BOA-16-11 Staff Report

Applicant:	Land Traditions, LLC
Property Owner:	Land Traditions, LLC
Zoning District:	Planned Unit Development (PUD)
Future Land Use Designation:	Residential
Character Area Designation:	Urban
Property Location:	4795 Fairways Lane (Traditions of Braselton, Phase 1, Pod G)
Acreage:	0.99 acres
Zoning Map and Parcel:	Map 105D Parcel 016G
Board of Commissioners District:	District 3 (Commissioner Ralph Richardson, Jr.)
Zoning and Land Use of Surrounding Property:	North: PUD, single-family residence South: PUD and AR, single-family residence and Traditions Golf Course East: PUD, single-family residence West: PUD and AR, single-family residence
Requested Variance:	Reduction of 50-foot county stream buffer from 50 feet to 10 feet
Type of Variance:	Special Exception Variance

Overview of the Request: The applicant is requesting a reduction of the outer 50 feet of stream buffer required by county regulations. The applicant is requesting a 40-foot reduction, from 50 feet to 10 feet. The 25-foot wide state imposed buffer is not proposed to be varied.

STAFF CONCEPT PLAN

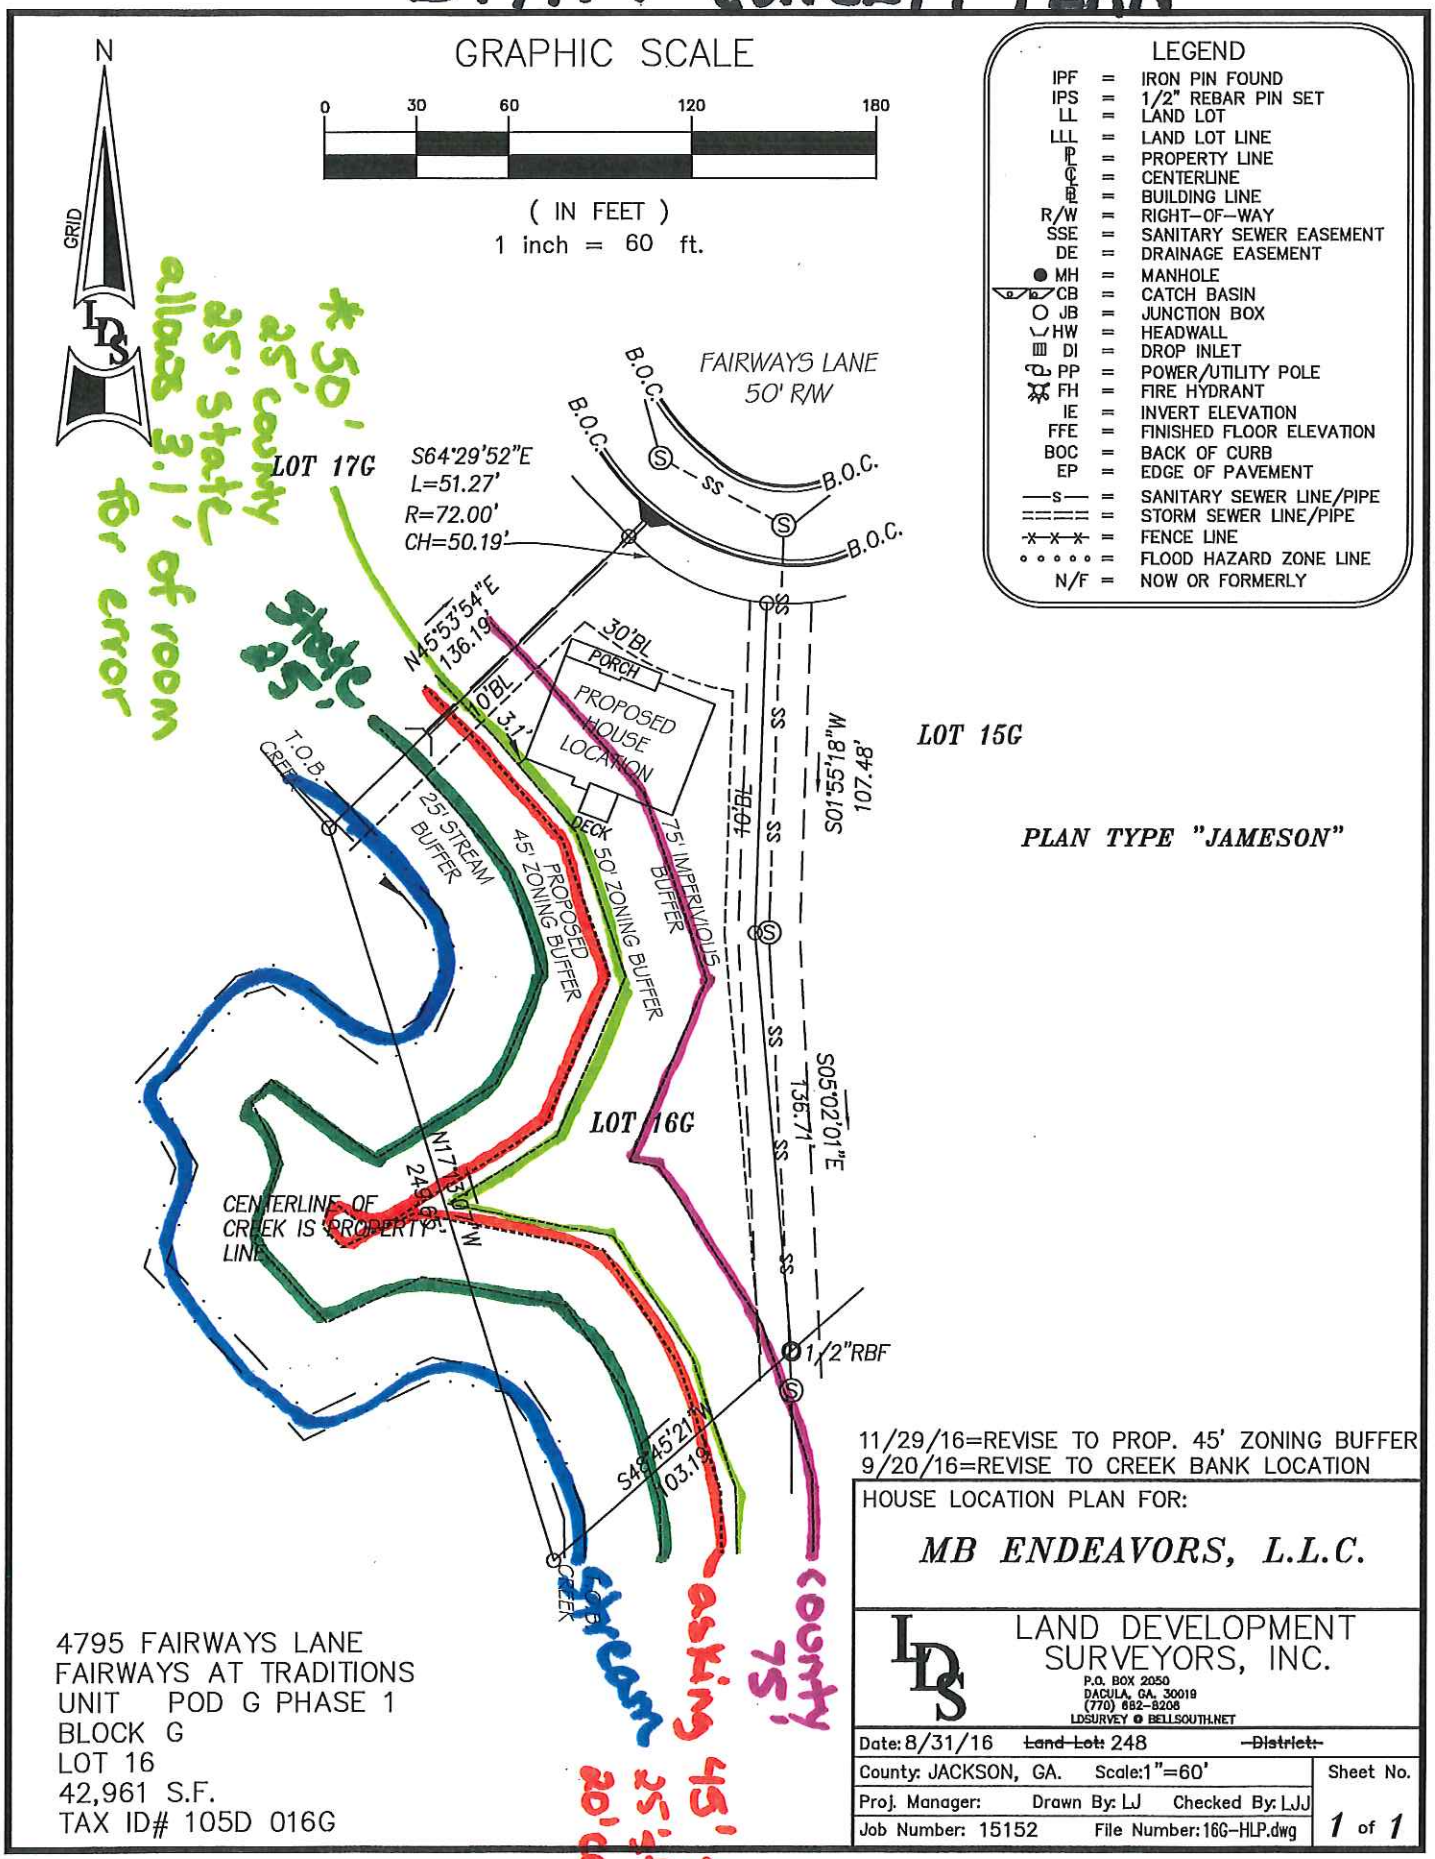
Please refer to the concept plan in the packet provided to show the variance requested. Currently the 50-foot county stream buffer runs through the center of the proposed house.

The applicant turned in a new concept plan after the case was initially tabled. Planning Staff has analyzed this new plan and annotated it with certain colors. The blue line is the stream itself. The dark green line is the 25-foot state imposed stream buffer. The purple line is the combined 75-foot stream buffer (county plus state imposed). The applicant has shown two additional lines on the concept plan. The orange line notes the "proposed" buffer reduction that the applicant is asking for. Instead of a 75-foot stream buffer, the applicant shows a proposed 45-foot stream buffer, therefore reducing the County's stream buffer from 50 feet to 20 feet. However, the light green line shows a total of 50 feet from the stream, allowing 3.1 feet of room for error. A 50-foot stream buffer would account for the 25-foot state imposed stream buffer and 25 feet of county stream buffer. This would not only allow the house to fit on the lot as shown, but also 3.1 feet of room for error.

Finding: There is no evidence that a full 40-foot reduction of the buffer is essential or necessary. After watching this particular waterway closely for the past six months through MS4 stormwater inspections, it is noted that this waterway is especially sensitive and the state and county greenway buffers are crucial to its well-being.

Planning Staff Recommendation: Staff has reviewed this application in conjunction with the standards for approval set forth by the Jackson County Unified Development Code. The staff recommends that the Board of Adjustment **deny** this request to reduce the county stream buffer by 40 feet. Planning staff does not feel as if 40 feet of the county stream buffer needs to be eliminated. However, staff would be in favor to grant some relief. If a reduction is granted by the Board, staff recommends that the buffer be reduced to no less than 20 feet outside the state-required 25-foot buffer (i.e., reduction from 75 feet to no less than 45 feet). Staff also recommends a condition be placed on the property: (1) southern and western portions of the property's yard be sodded.

Revised Planning Staff Recommendation: Staff has reviewed this application in conjunction with the standards for approval set forth by the Jackson County Unified Development Code. The staff recommends that the Board of Adjustment **deny** this request to reduce the county stream buffer by 40 feet. Planning staff does not feel as if 40 feet of the county stream buffer needs to be eliminated. By looking at the applicant's concept plan, staff has noted that according to the concept plan, a 30-foot reduction would be sufficient. This would not only allow the applicant enough room for the proposed house, but also 8.1 feet of room for error. Therefore, staff would be in favor to grant some relief. If a reduction is granted by the Board, staff recommends that the buffer be reduced to no less than 20 feet outside the state-required 25-foot buffer (i.e., reduction from 75 feet to no less than 45 feet). Staff also recommends two conditions be placed on the property: (1) southern and western portions of the property's yard be sodded and (2) have the builder submit a house location plan, designed by a licensed engineer or surveyor, after pouring the foundation for review by the Public Development Department to meet the varied setback requirements before any other inspections can be performed.
